20 August 2020

Ref: E31425PletRev1-ADDRAP

**ADDENDUM TO REMEDIATION ACTION PLAN
PROPOSED DEVELOPMENT OF PARRAMATTA WEST PUBLIC SCHOOL
CRIMEA STREET, PARRAMATTA, NSW**

Title:		PREVIOUS SITE FEATURES AND SAMPLE LOCATIONS	
Location:		PARRAMATTA WEST PUBLIC SCHOOL, CRIMEA STREET, PARRAMATTA	
Project No:		E31425PletRev1-ADDRAP	Figure No: 2
JK ENVIRONMENTS

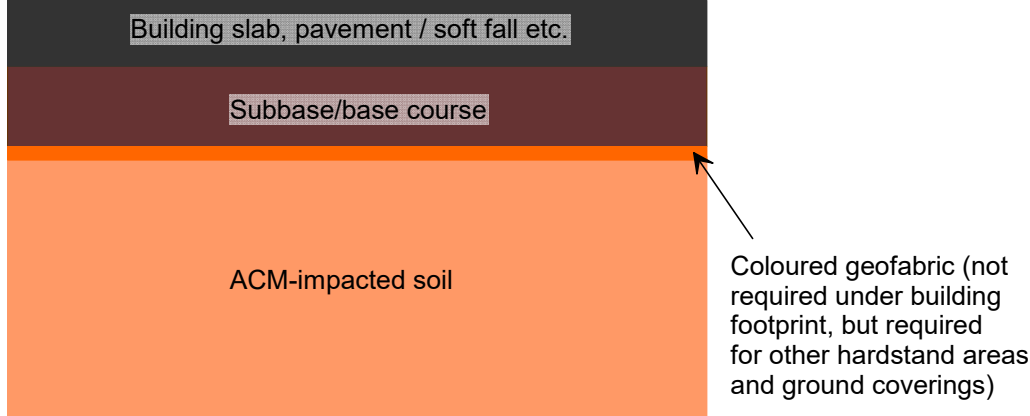
The RAP included a nominal area of remediation around location TP32 (see Figure 2, Appendix A) where PAH contamination was identified in the shallow fill. The PAH contamination in shallow soil at TP32 was at an unacceptable level, but was acceptable or not detected elsewhere.

Additional soil samples have been collected from the vicinity of TP32 as part of the site validation process and an initial review of these results indicated that the occurrence of PAHs in fill in the western part of the site is likely to be widespread, albeit at lower concentrations than originally reported in TP32 (the maximum carcinogenic PAH concentration from the validation sampling was 6.3mg/kg and only three of the 34 samples exceeded the 3mg/kg threshold). The PAHs are considered to be attributed to ash, metallurgic furnace slag and/or asphaltic concrete fragments in the fill matrix (all three of these inclusions were found in trace quantities in the fill). Further details are to be presented in the site validation report.

For the purpose of the remediation, site validation and long-term management of the site, the fill in the western area of the site will be deemed to be contaminated with carcinogenic PAHs at concentrations above the Validation Assessment Criteria (VAC). Due to the inferred extent, the original remediation approach proposed in the RAP (i.e. delineate, excavate and dispose) will not be implemented. The 'cap and contain' strategy (initially proposed for asbestos remediation), is considered to be a suitable alternative approach to address the risks associated with PAHs in fill, and this has been reflected in this addendum RAP.

Title: CONCEPTUAL CAPPING SPECIFICATION	
Location: PARRAMATTA WEST PUBLIC SCHOOL, CRIMEA STREET, PARRAMATTA	
Project No: E31425PletRev1-ADDRAP	Figure No: 3
JK ENVIRONMENTS

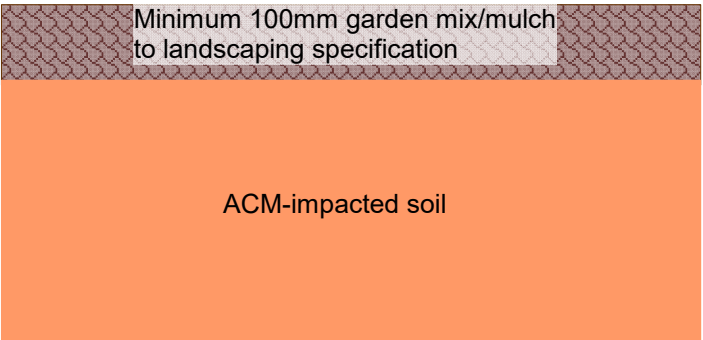
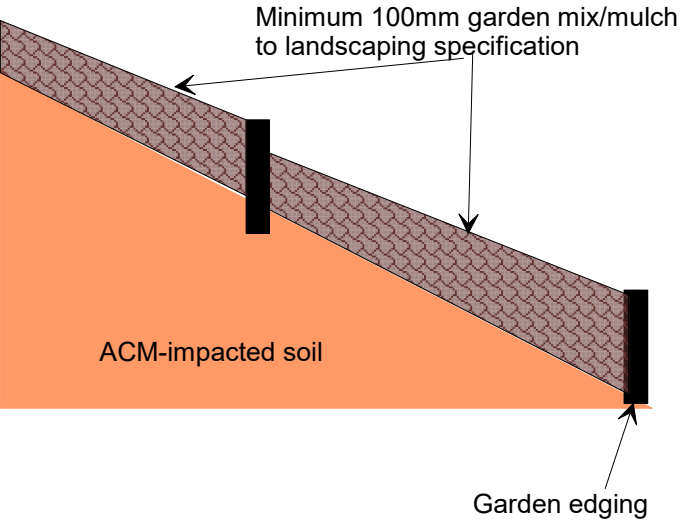
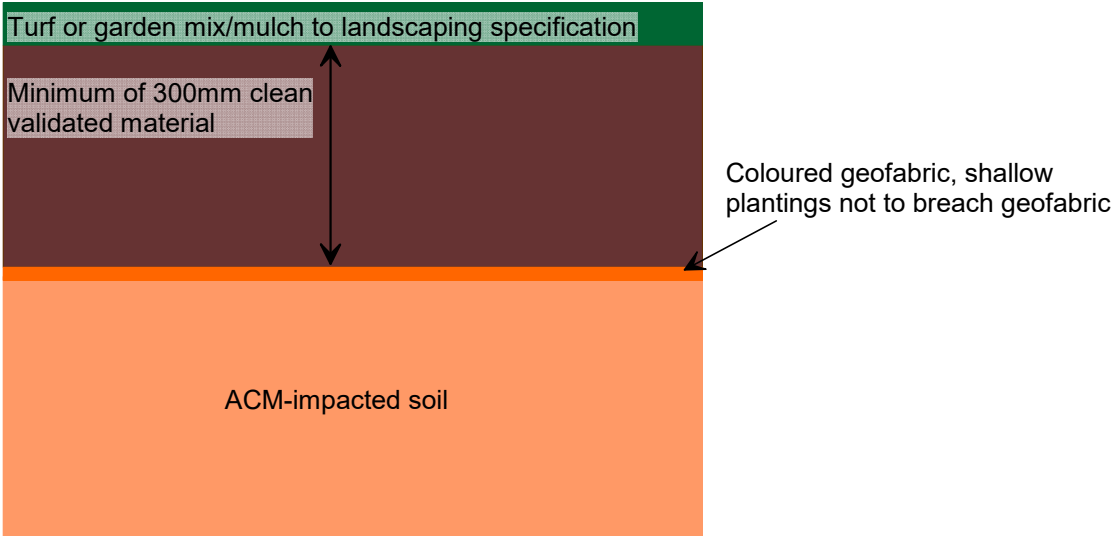
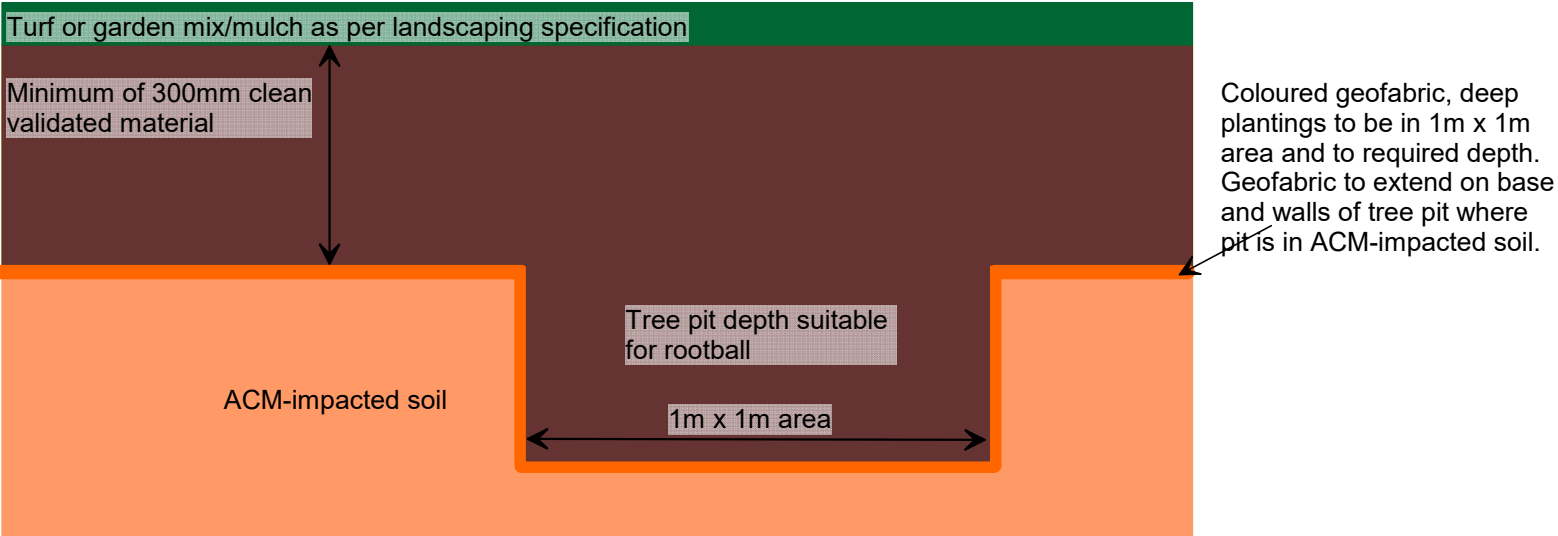
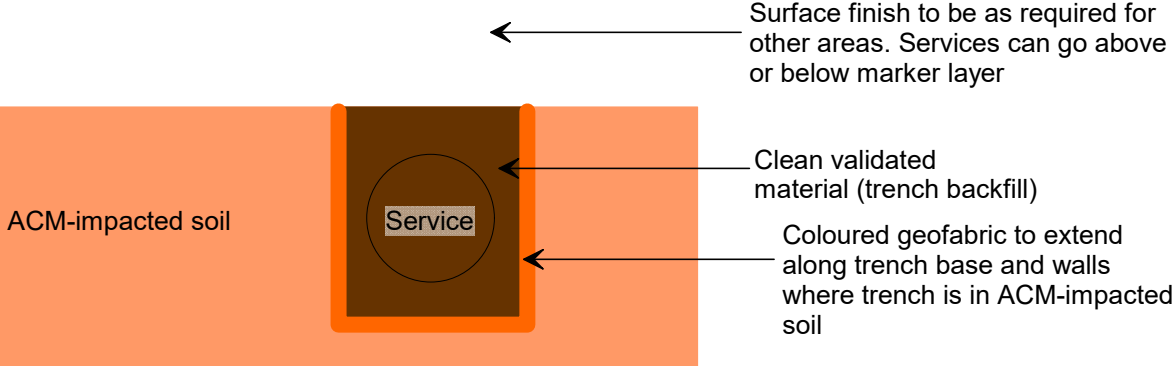
The amended capping specification for the site is provided in the table below. Conceptual cross sections for each capping specification are shown on Figure 3 in Appendix A.

Area / Finished Surface	Capping Specification
Building footprint. (Capping Type A optional)	Subbase/basecourse and building slab as per the relevant engineering specification. Although not specified under this addendum RAP, it is understood that the client may elect to also place coloured (preferably orange) geofabric ² overlying the ground surface beneath the structural slab.
Hardstand surfaces, paved areas and areas with continuous surface coverings such as soft fall that are outside building footprint. (Capping Type A)	Coloured (preferably orange) geofabric overlying the ground surface (unless surface can be confirmed/validated as virgin material), followed by the subbase/basecourse and pavement/soft fall as per the relevant engineering/construction specifications.
Battered areas around the site boundaries and areas where trees are to be retained (i.e. where excavation and installation of 300mm clean soil cap cannot/will not occur). (Capping Type B and B2)	Minimum of 0.1m woodchip mulch, or another suitable product as agreed with the Validation Consultant and Site Auditor. The use of tiered garden edging/stabilising measures may be required to retain the 0.1m thick layer depending on the grade of the batter.

Unpaved areas including landscaped or grassed areas with shallow plantings and/or turf (excludes battered areas and existing tree areas as noted above). (Capping Type C)	Coloured (preferably orange) geofabric overlying the ground surface (unless surface can be confirmed/validated as virgin material), overlain by a minimum cap of 300mm comprising clean (validated) imported material or site-won Virgin Excavated Natural Material (VENM). Turf would subsequently be laid over the 300mm cap where required. Shallow plantings are not to extend deeper than the geofabric.
Unpaved areas including landscaped or grassed areas with new tree plantings (excludes battered areas and existing tree areas as noted above). (Capping Type D)	Coloured (preferably orange) geofabric overlying the ground surface (unless surface can be confirmed/validated as virgin material), overlain by a minimum cap of 300mm comprising clean (validated) imported material or site-won VENM. Turf would subsequently be laid over the 300mm cap where required. Tree plantings, assuming they require installation to a depth beyond the 300mm cap, would need to be boxed out over a 1m by 1m area or as

appropriate considering the size of the root ball and future growth of the tree. The base and side walls of the tree pit is to be lined with the coloured (preferably orange) geofabric (unless base/walls can be confirmed/validated as virgin material) which is to be appropriately secured to the geofabric adjoining the tree pit. The tree pit is to be backfilled using clean (validated) imported material.
Underground services (Capping Type E)	All services are to be placed in trenches backfilled with clean, validated material. Trenches in fill are to be lined at the base and walls with coloured (preferably orange) geofabric. Capping finishes above the service trenches are to align with the above scenarios. Existing underground services, such as the sewer in the western area of the site, will remain beneath the final cap.

Title: **PRELIMINARY CAPPING ARRANGEMENT**

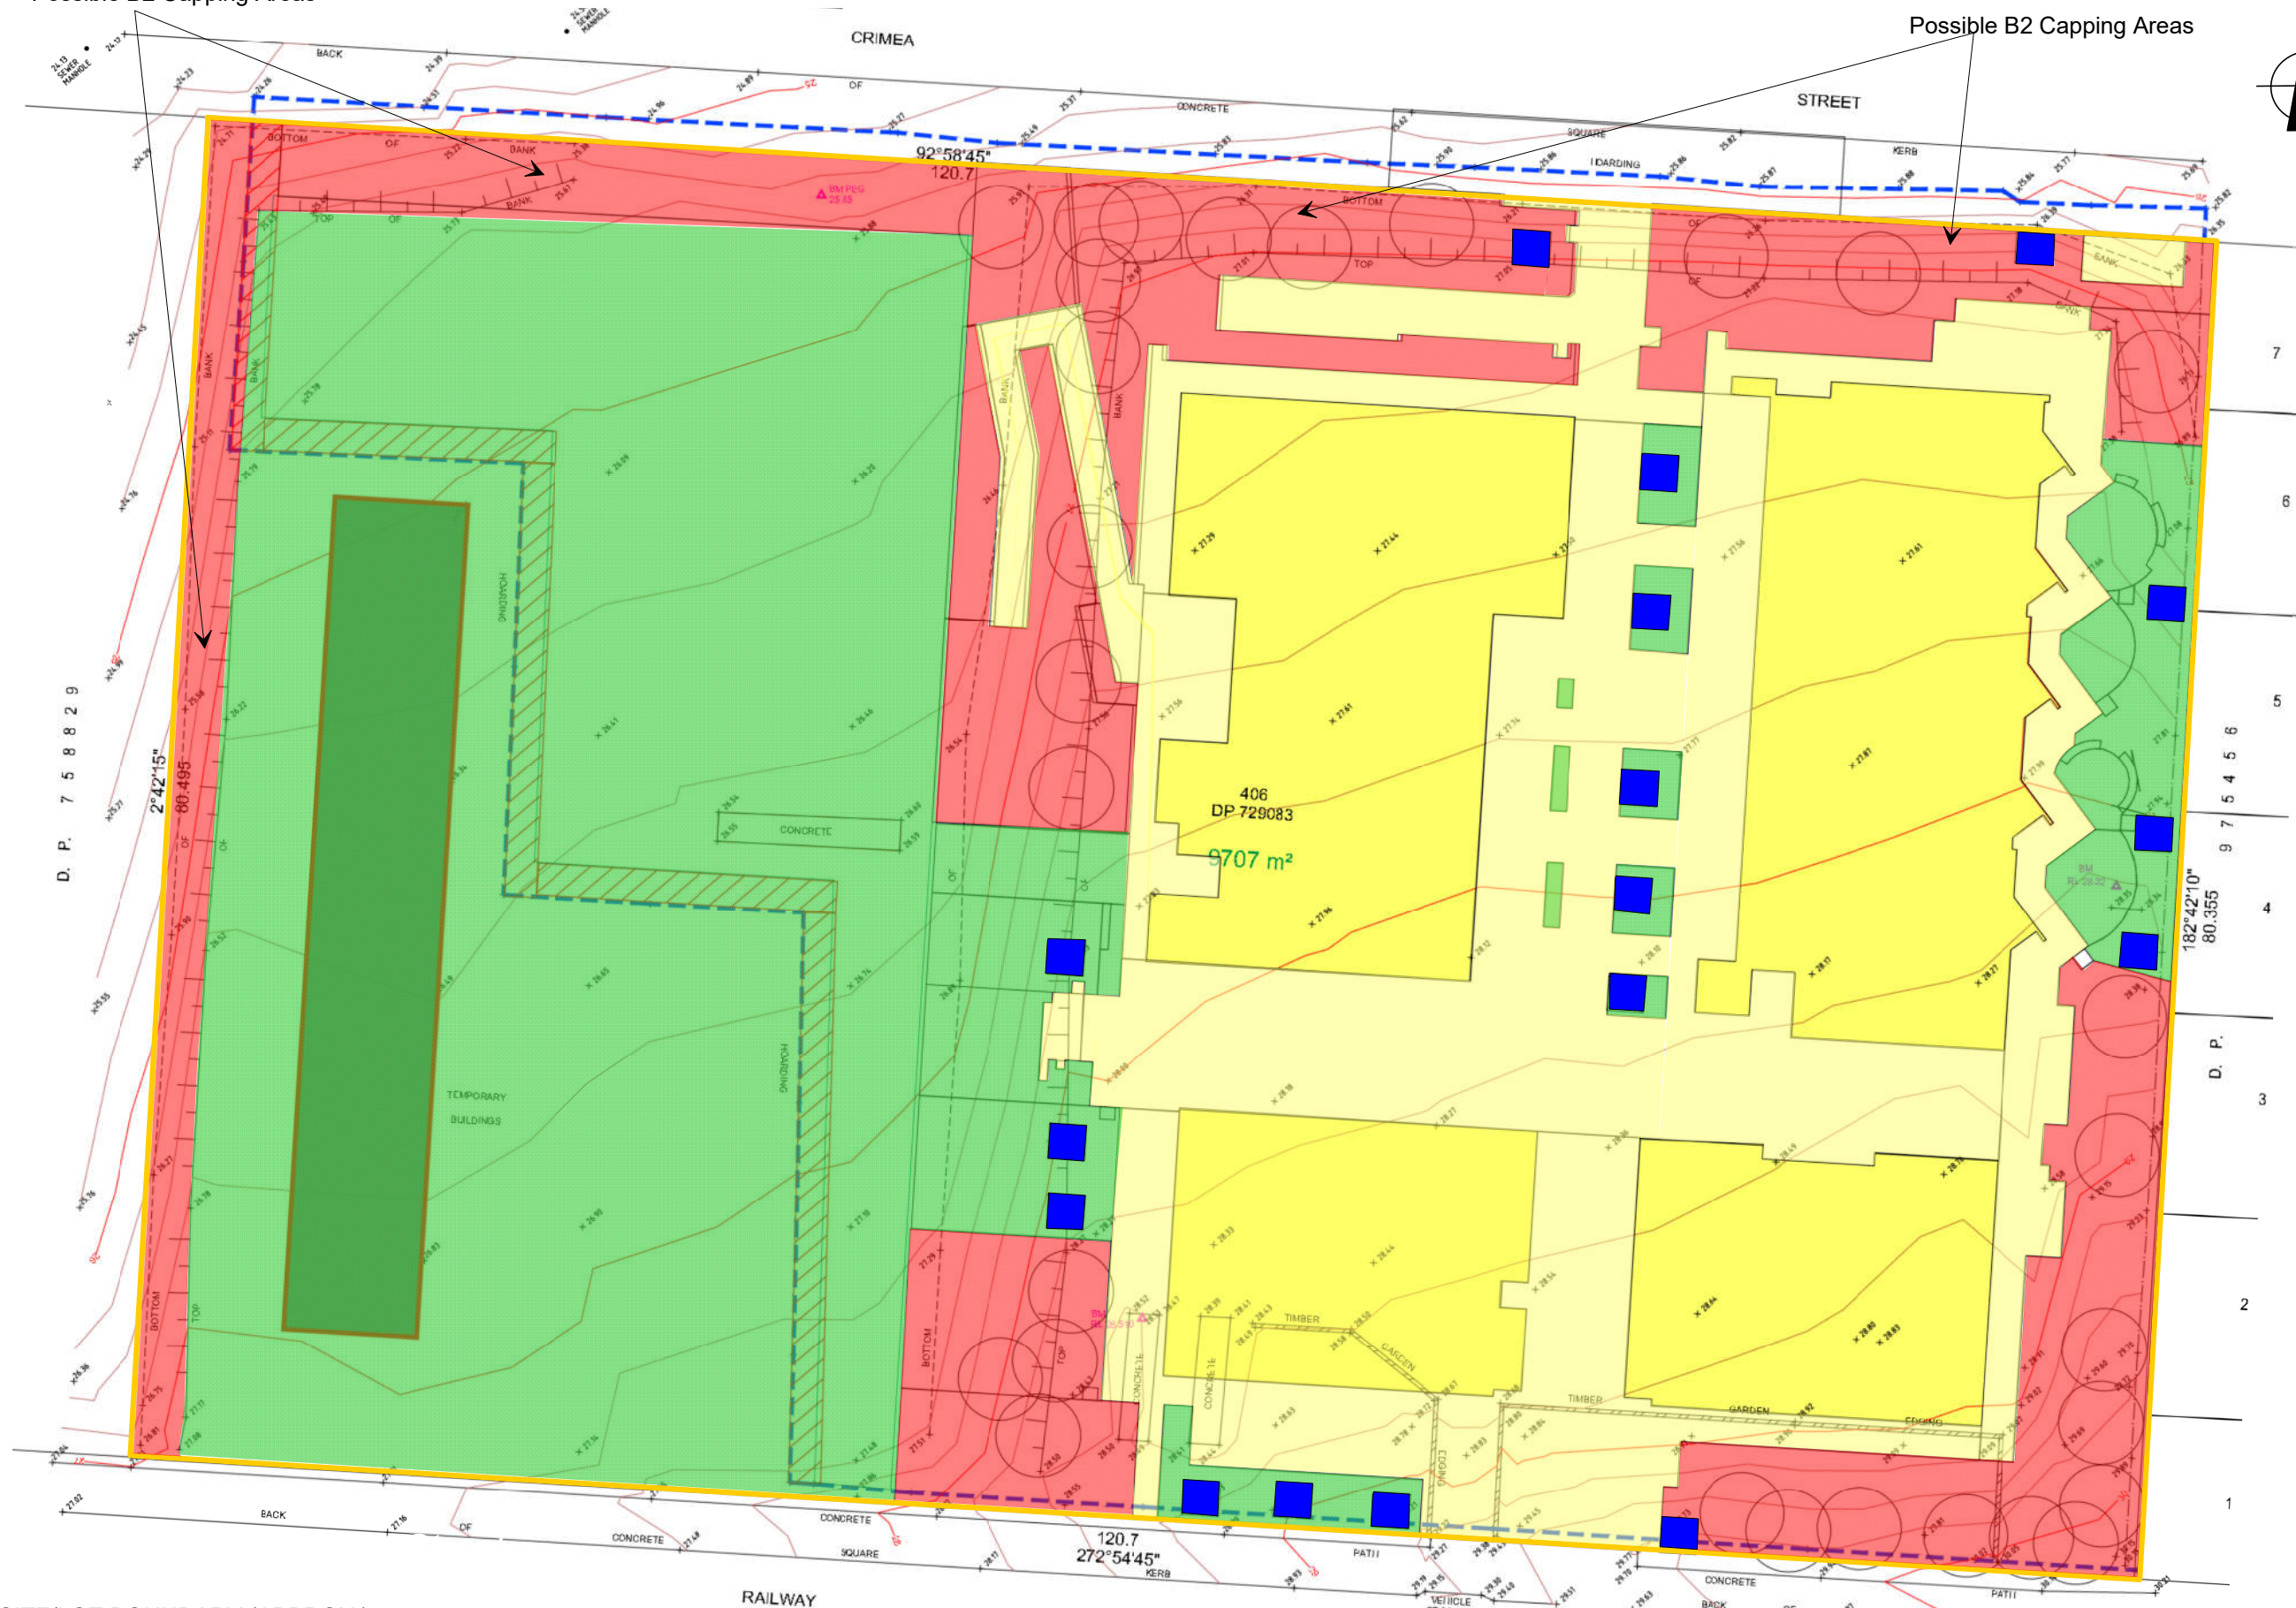
Figure 4 in Appendix A presents the preliminary capping arrangement across the various areas of the site. Alterations to this plan are to be reviewed by and approved by the Validation Consultant and the Site Auditor.
